From: Hoellman, Jordan
Sent: Thursday, April 07, 2016 12:59 PM
To: Vogle PEmails
Subject: Qualitative impact assessment on the Vogle global seismic model due to proposed changes to Wall N (LAR-131) --UPDATED--
Attachments: DCP-5248_Impacts to Seismic Analysis_Due to Wall N +4in__04-04-2016 WEC 2016-04-07.docx

Proposed change of DCP 5248, Rev. A (Applicable to only plants SV3, SV4):

VEGP 3&4 – UFSAR

Figure 3H.5-1 (Sheet 1 of 3)
[Nuclear Island Critical Sections
Plan at El. 135'-3"]

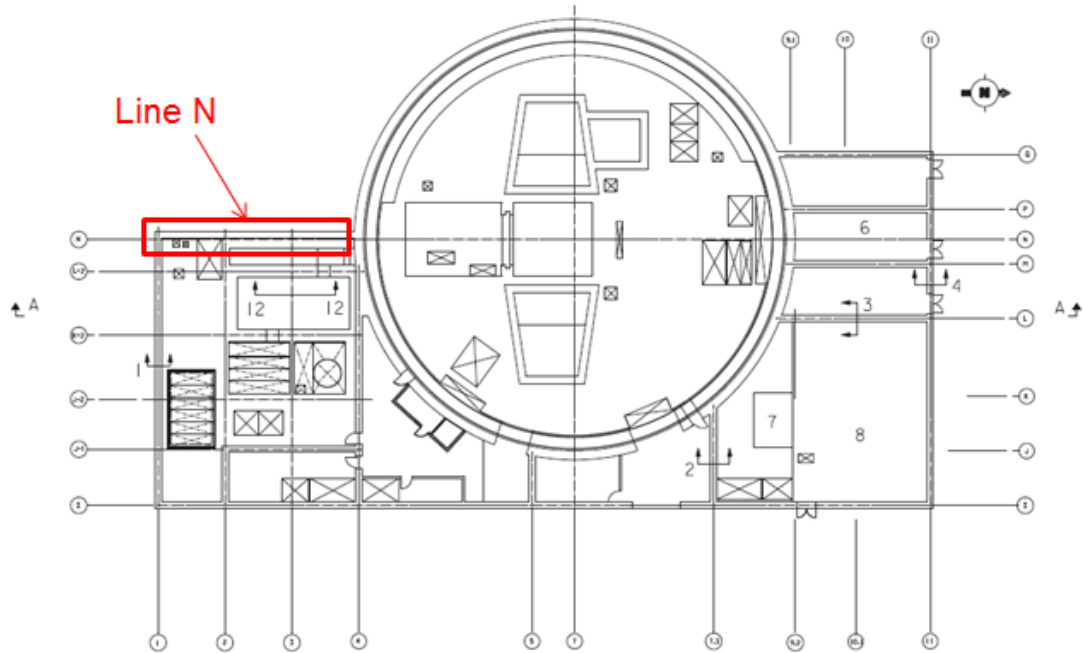
Change Tier 1 Table 3.3-1 wall thickness tolerance from +1" to +4" for Column Line N Wall from Column Lines 2 to 4 (44 feet) from Elevations 98'-1" to 135'-3."

Wall N:

The proposed change does not have an adverse impact to the Vogtle site specific nuclear island seismic analysis or the design response spectra for Vogtle based on the following reasons:

- Considering a +4" tolerance for the 66" thick wall results in a maximum of only 6% increase in mass for this local area of the nuclear island compared to the nominal dimensions. The increase in mass is negligible compared to the total mass of the nuclear island, and will not result in a sizeable change to the dominant modes of the structure.
- The change to the local region of the nuclear island is relatively small, and will not result in a significant change in structural response in this local area or adjacent areas.
- The seismic response spectra generated as input to structures, systems, and components is broadened by +/-15 percent to account for variations in structural frequencies due to uncertainties in parameters such as material and mass properties of the structures and the soil, damping values, seismic analysis technique, and the seismic modeling technique.

Figure 21 Horizontal X Response Spectra at ASB Corner of Fuel Building Roof at Shield Building (El. 179.19 ft, Node 11111)

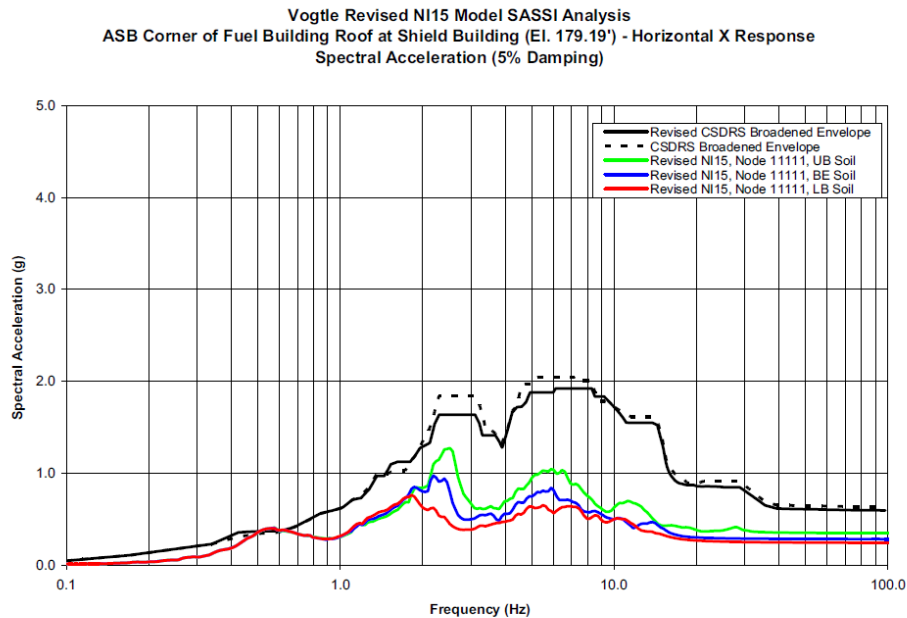
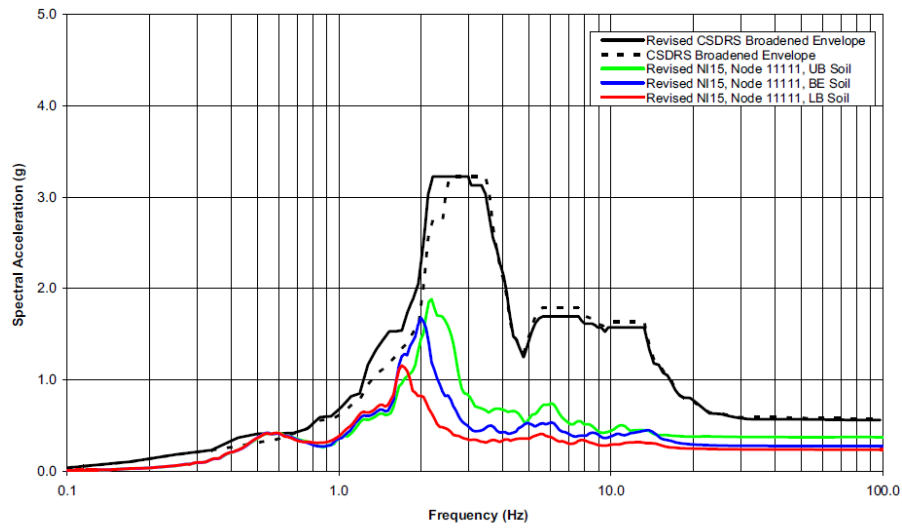
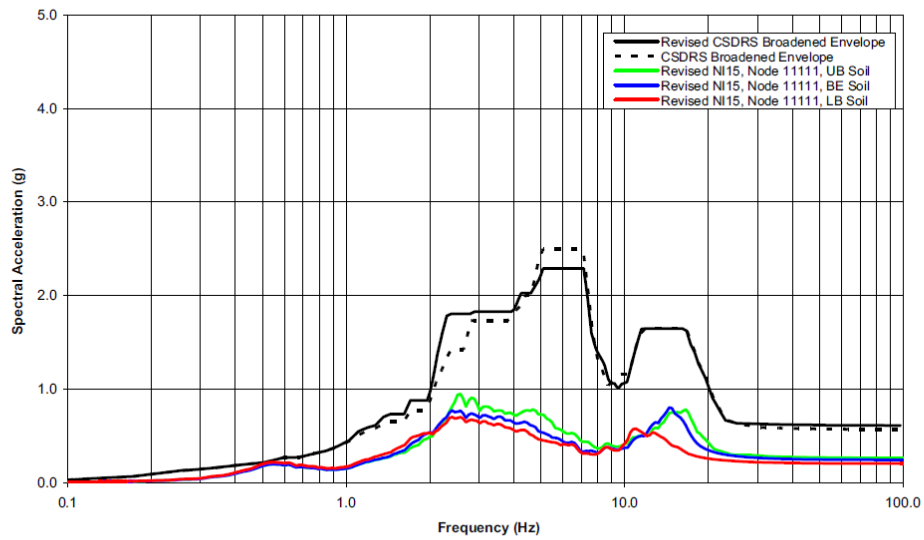
Furthermore, the seismic responses at Vogtle Units 3 & 4 are generally low in comparison to the AP1000 seismic design response spectra. Thus, the seismic design forces and the AP1000 configuration at Vogtle would not be adversely affected.
